# UNITED STATES PATENT AND TRADEMARK OFFICE

# Office Action Summary

09/983,047

## **DETAILED ACTION**

Figure 3a - U.S. Patent 6,218,661 to Schroeder et al., filed 10.16.98

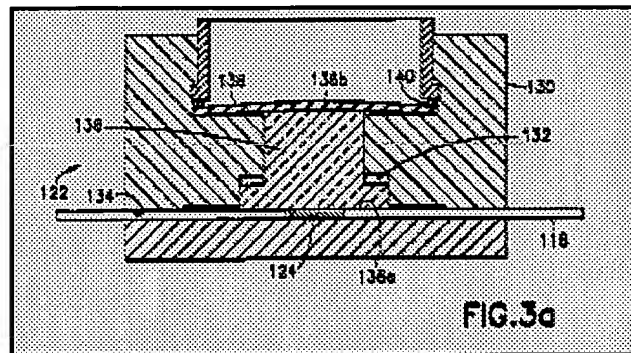
2. As per claim 1, 11 and 13, Schroeder et al. disclose an apparatus comprising at least one optical fiber (118) (see also Fig. 4 – not shown above – 234, 235) supported in a structure (130); a movable mass (136) supported within the structure (130) and means (Fig. 1, not shown above; i.e. 12, 14, 16, 18, 20, 22, 24, 26) for detecting changes in tension in the at least one optical fiber due to movement of the movable mass (132) – (see abstract, Figs. 1-3).

3. As per claim 2, Schroeder et al. disclose an apparatus wherein the detecting means comprise at least one fiber optic Bragg grating (Fig. 3, 124) written into a core of each of said optical fibers.

5. As per claims 8 and 9, Schroeder et al. disclose an apparatus wherein the structure comprises a cage (Fig. 3 above) and wherein a gap is provided between each side of the mass and cage; the gap being sufficiently small to limit motion of the mass in shock or high acceleration and to limit the maximum tension seen by each of the optical fibers.
